REMARKS

Objection to the Drawings

FIG. 3

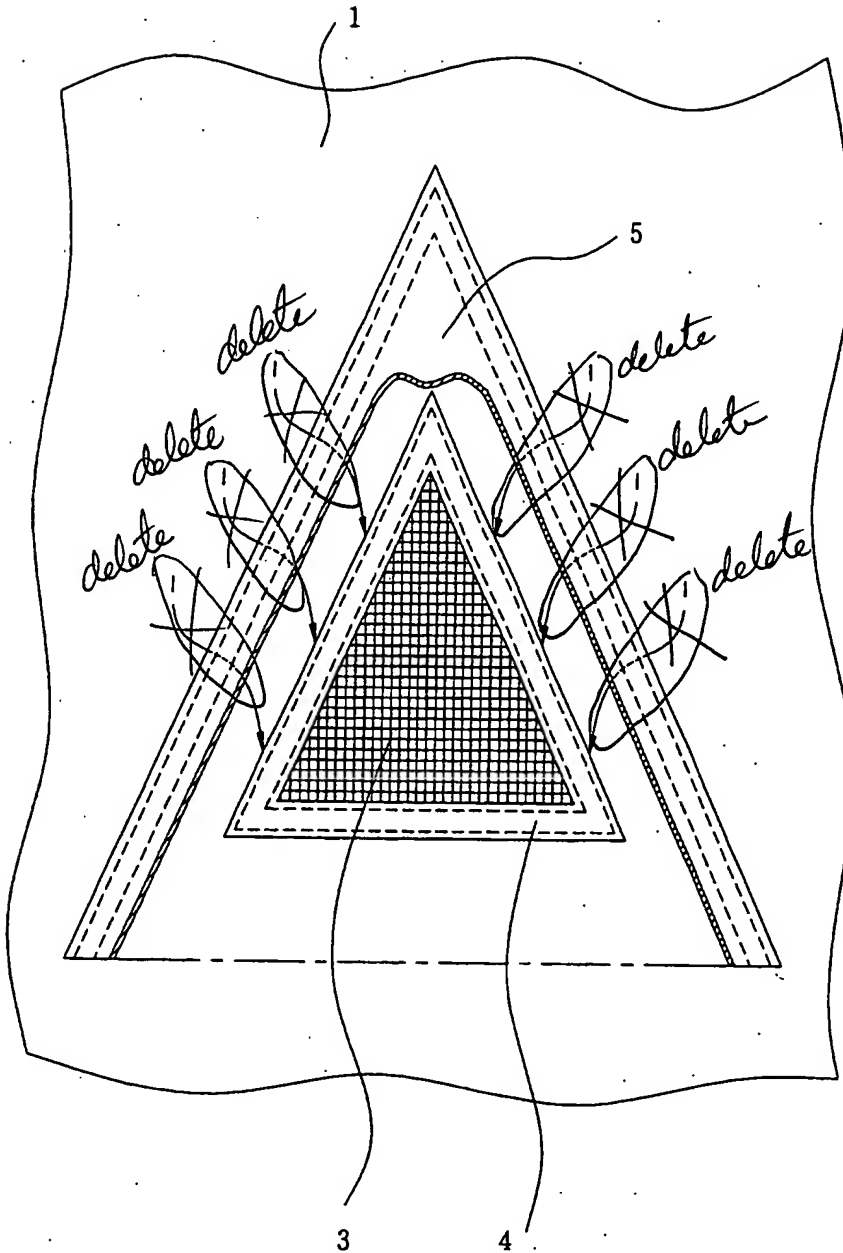
Figure 3 of the drawing stands objected to because reference numeral 1 has been used to designate more than one element. Applicant submits that six arrows in the middle of the drawings were used to show the rainwater penetration. In order to remove the confusion, Applicant has removed those arrows. Applicant herewith submits a replacement drawing for figure 3 in compliance with 37 CFR 1.121(d).

FIG. 4

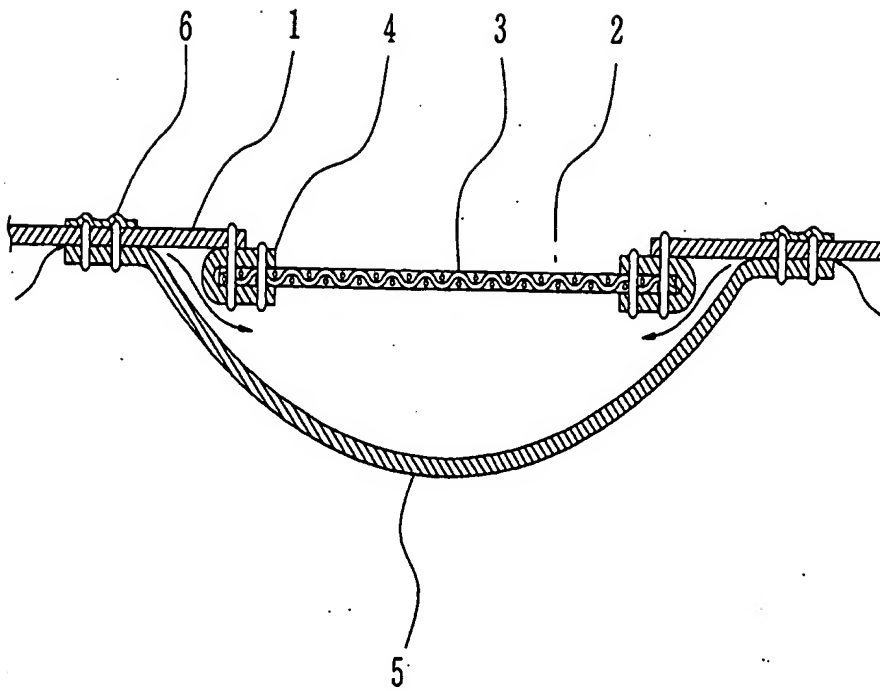
Figure 4 of the drawing stands objected to because a legend such as --Prior Art—is required. In response, a replacement drawing including the legend is submitted herewith.
